Greg Lewicki and Associates, PLLC

June 30, 2015

✓ **RE: Revenue Mine, Permit M-2012-032, Amendment AM-1
Adequacy Review #1 Response**

Map C-12: Tailings Transfer Pad
Revenue Mine
Fortune Revenue Silver Mines, Inc.

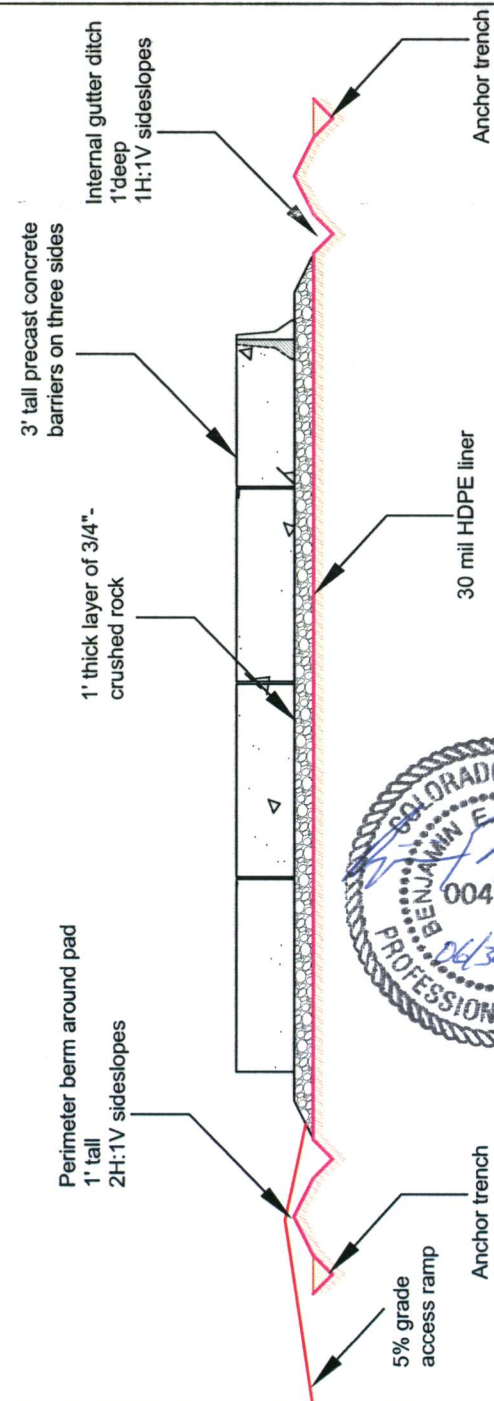
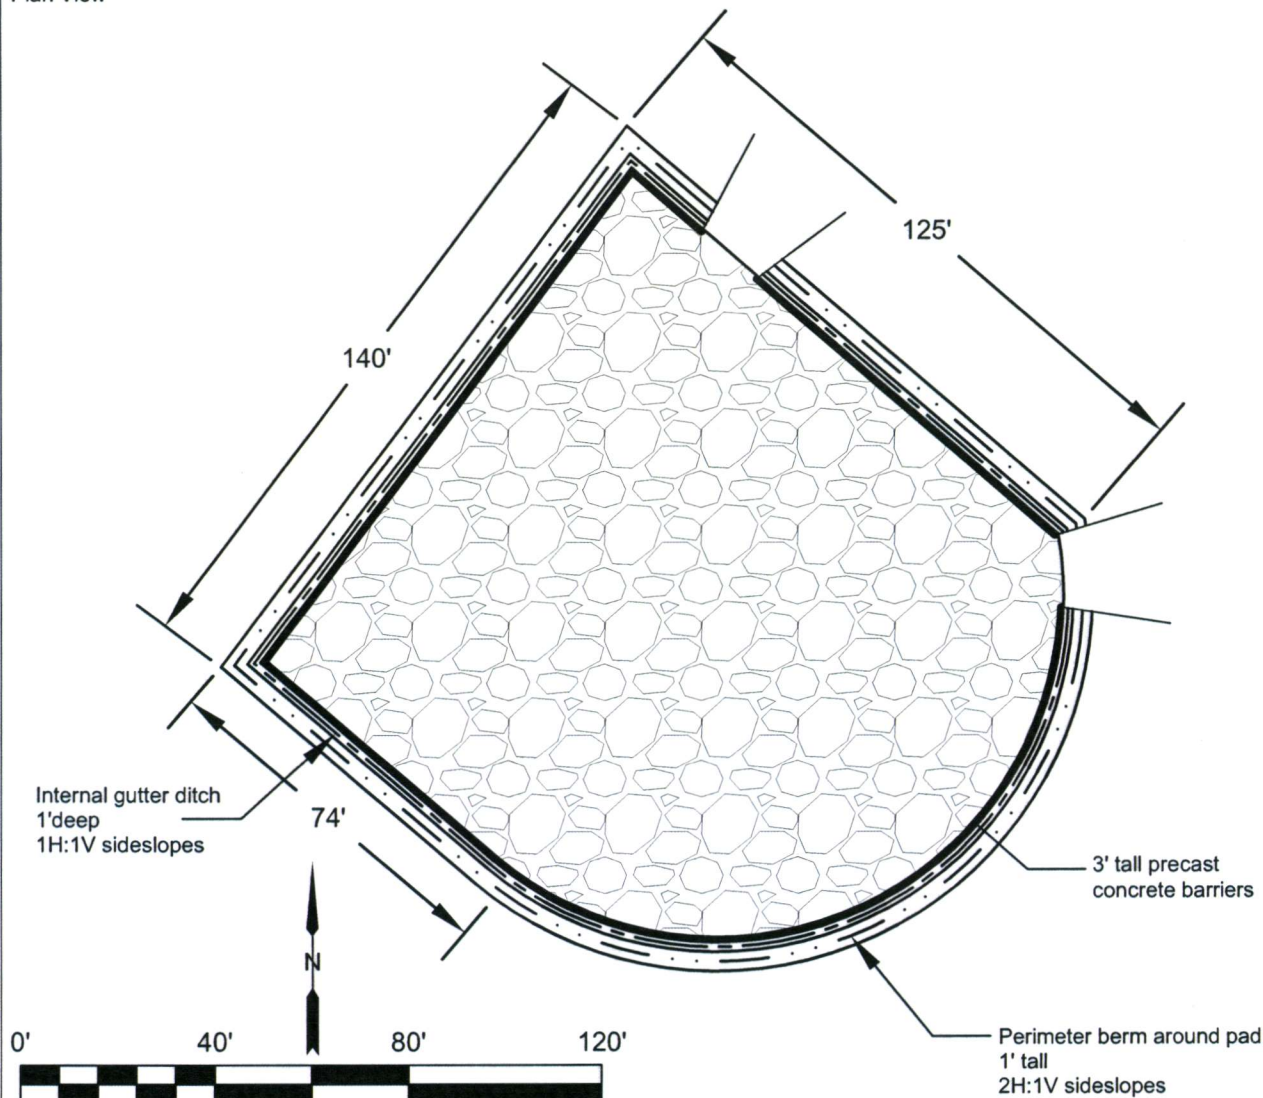
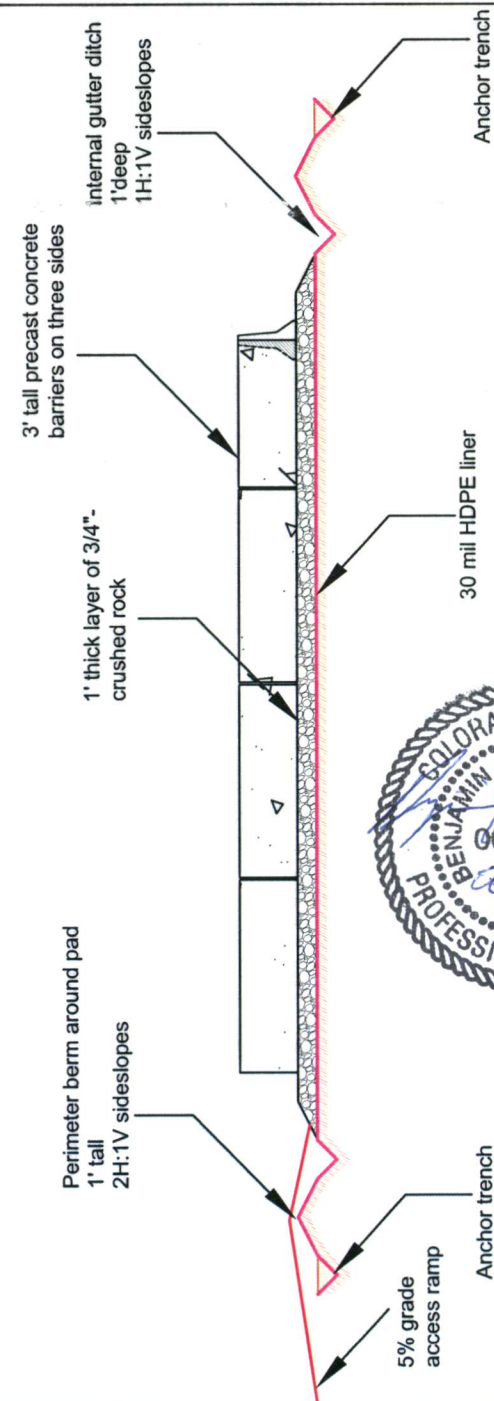
- 2. Please provide more information about these features that appear on the Revenue Mine area maps (such as Map C-4, for example): the "potentially contaminated concrete lined tailings storage area" near the thickener, and the "temporary wet tailings storage area (unlined)" behind the dry building.**

Map C-12 shows the design of the “Potentially Contaminated Concrete Lined Tailings Storage Area”. The “temporary wet tailings storage area (unlined)” located behind the dry building and avalanche protection berm is where tailings is stored during the winter when it cannot be safely spread and compacted due to weather. Starting in spring of each year, the tailings from this area is spread out into the lifts required for permanent storage, once all of the snow has melted.

Map C-13: Ore Pad
Revenue Mine
Fortune Revenue Silver Mines, Inc.

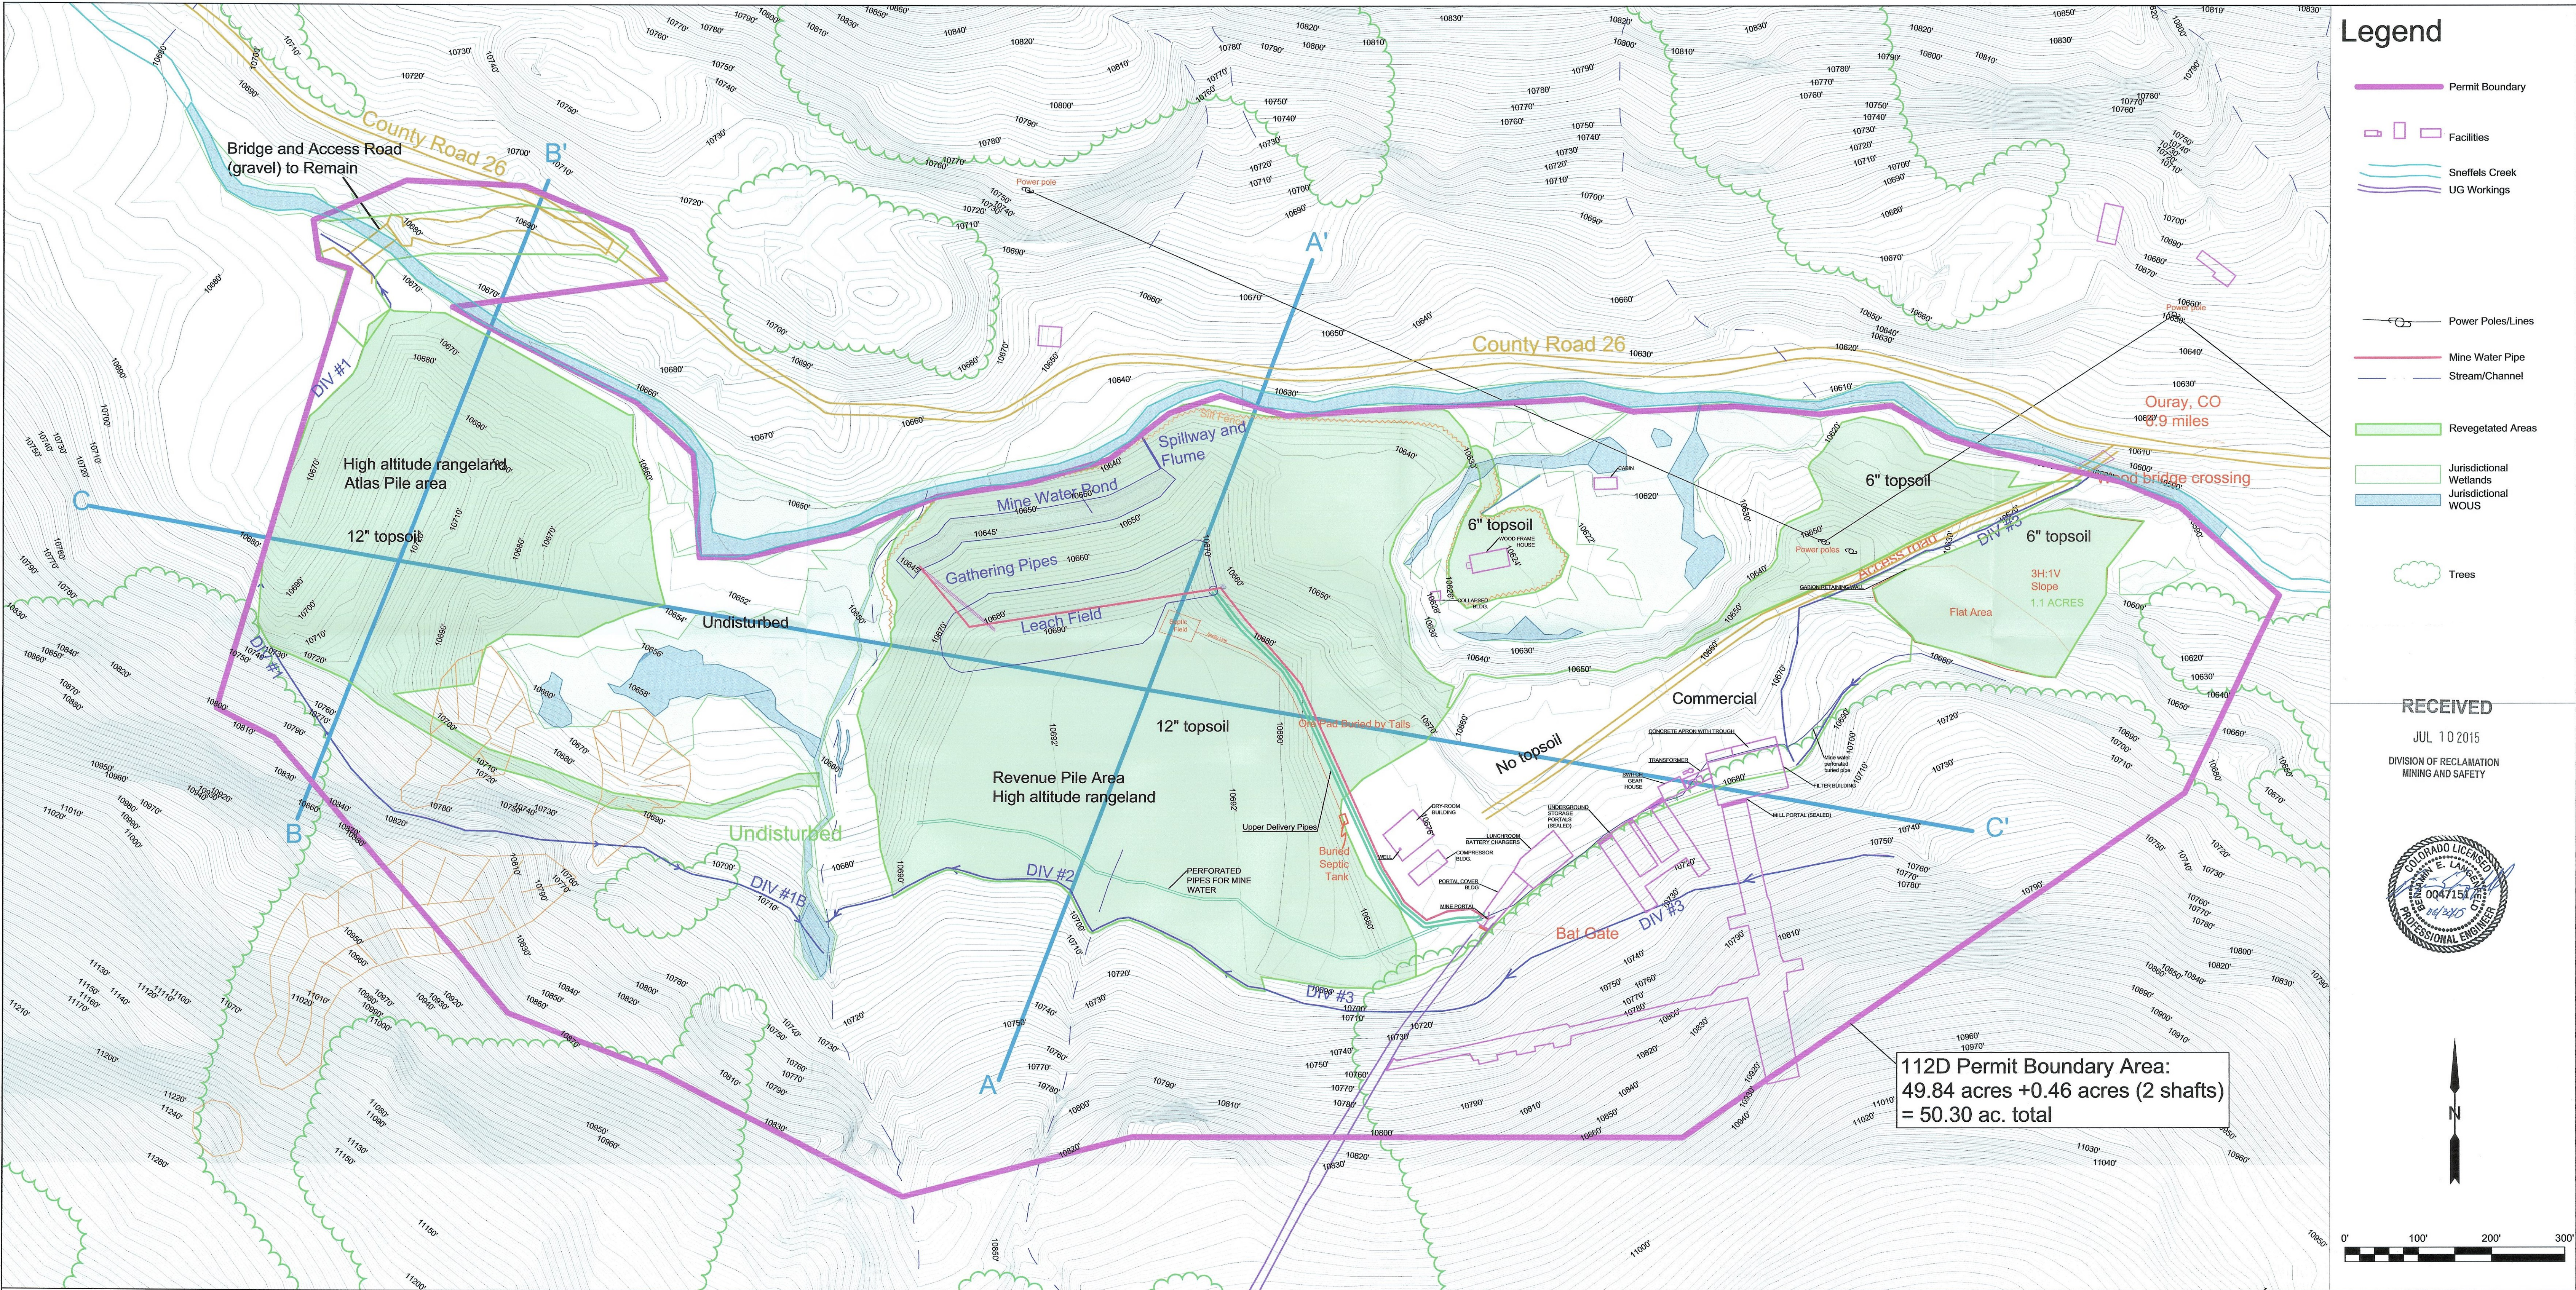
- 11. The narrative for Section 8 on page D-24 mentions an ore storage pad to be built. There is no follow-up description of the site preparation or construction details for this pad, though it is required. Detailed drawings that will be provided should include a cross section. Please provide this information.**

Map C-13 shows the details of this ore pad. Revised page D-24 now references Map C-13.

Map F-1: Reclamation Plan
Revenue Mine
Fortune Revenue Silver Mines, Inc.
M-2012-032 AM01
Adequacy Review #1 Response

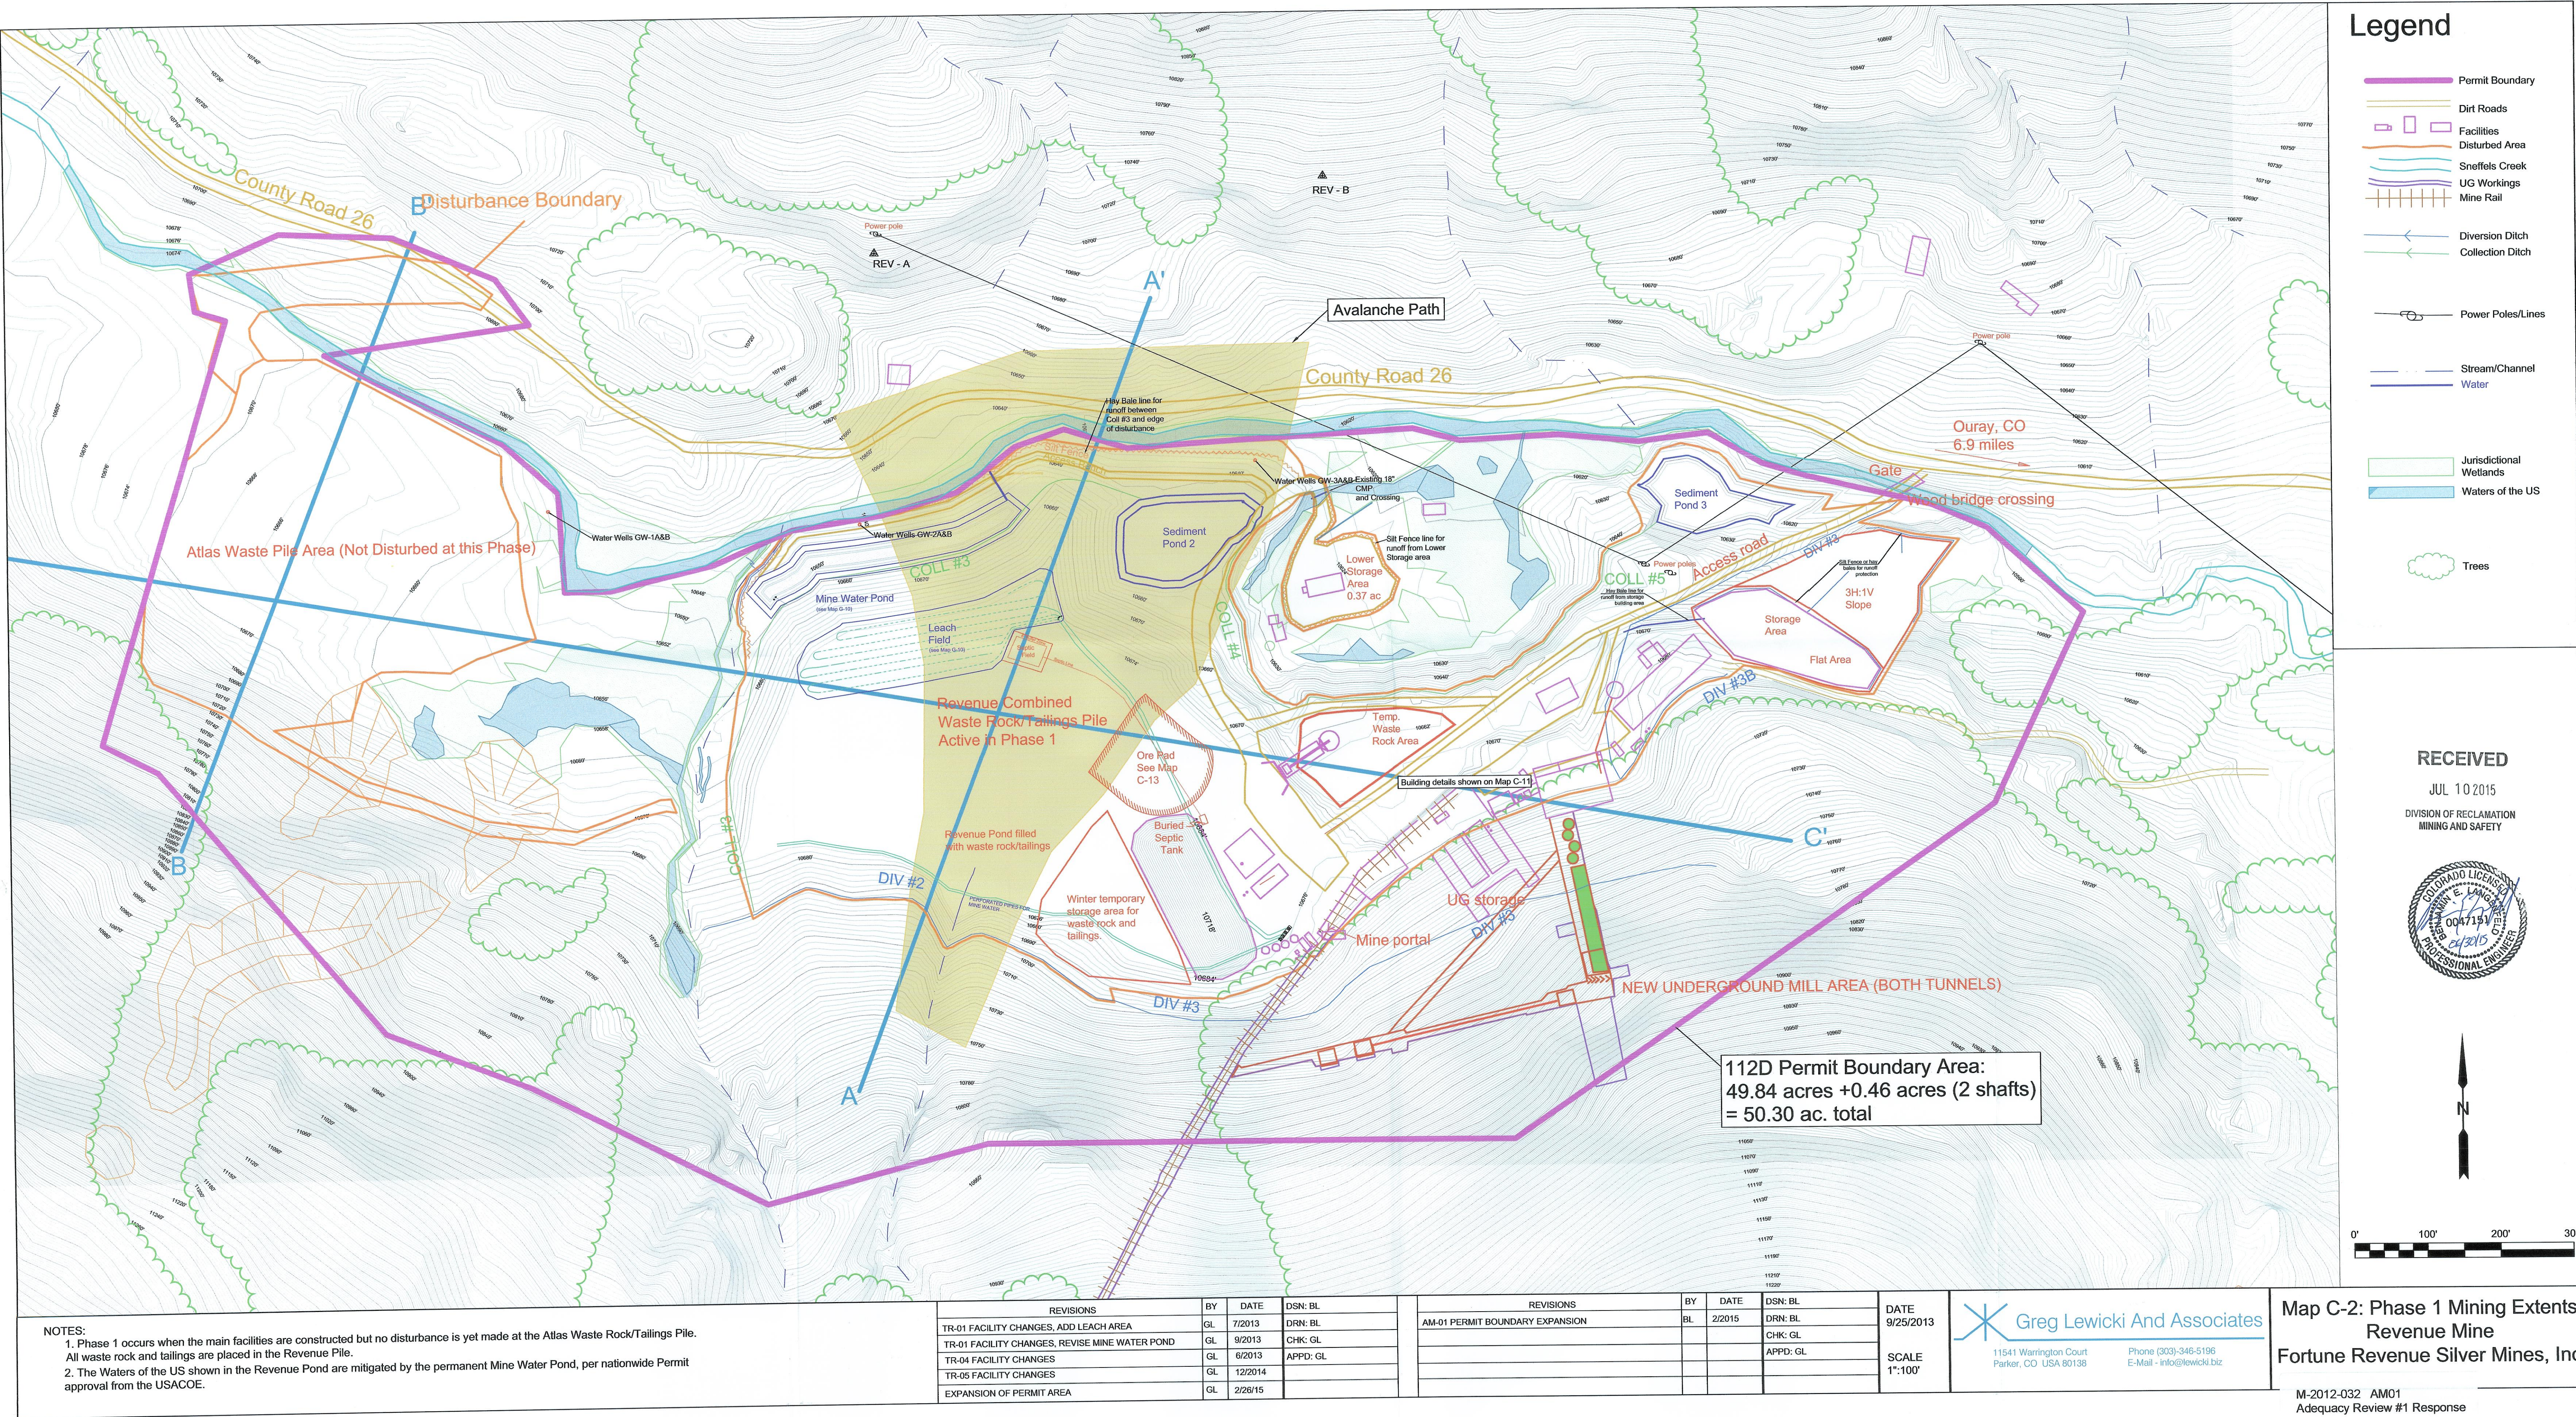
- 22. According to the Reclamation Plan in Exhibit E, all affected sloped areas are to be reduced to a maximum 3H: 1V gradient. However, the slope gradient shown for Waste Rock Area 3 (East End) on Map F-1 is not 3:1. Please correct this.**

- 23. It is permissible for the maps to continue to include the leach pond and the lines leading into and out of it, because they were previously approved for the plan, even though they may not actually be installed. However, please clarify and/or correct these labeled features also on Map F-1: mine water perforated buried pipes to the mine pond, and the perforated pipe crossing in front of the mill filter building.**

- 24. The topography shown for the road and slope located northwest of the crusher is far steeper than 3H:1V, though this slope should be reduced to 3:1. Please revise the contours to correct this area too.**

- 25. The Exhibit E narrative says the compressor building will be removed, yet it still appears on the Reclamation Map F-1. Please clarify or correct the map, for this detail.**

- 26. Section 10 of Exhibit E states that all access roads will be permanent, but the Atlas access road is not shown (besides by the new bridge location) on the reclamation map. Please show this road on a revised Map F-1.**

- 27. Map F-1 shows the green "land use boundaries" to delineate areas to be topsoiled and seeded from those that will not be. There are four locations where that boundary is depicted as a double line, which is unclear. These areas are: on the East Waste Rock area by the gabion wall; east of Atlas Creek; a strip of land above and south of the Atlas tailings area; and the area bordering the new (west) bridge. Please clarify this by cleaning up the boundary line or explaining what is meant by the double line.**

Map F-1 has been revised to reflect the 3H:1V slopes in the Waste Rock Area 3.

All water conveyance and treatment items are remaining as is in the permit for the time being. The perforated buried pipes to the mine pond are labeled as Upper Delivery Pipes on Map F-1. The perforated mine water discharge pipes are shown in the correct location on Map F-1.D

See the revised Map F-1.

The compressors have been removed from Map F-1.

Map F-1 has been revised to show the road crossing area clearer. Only the crossing will remain; the rest of the Atlas access road will be reclaimed.

The revegetation areas on Map F-1 have been clarified.
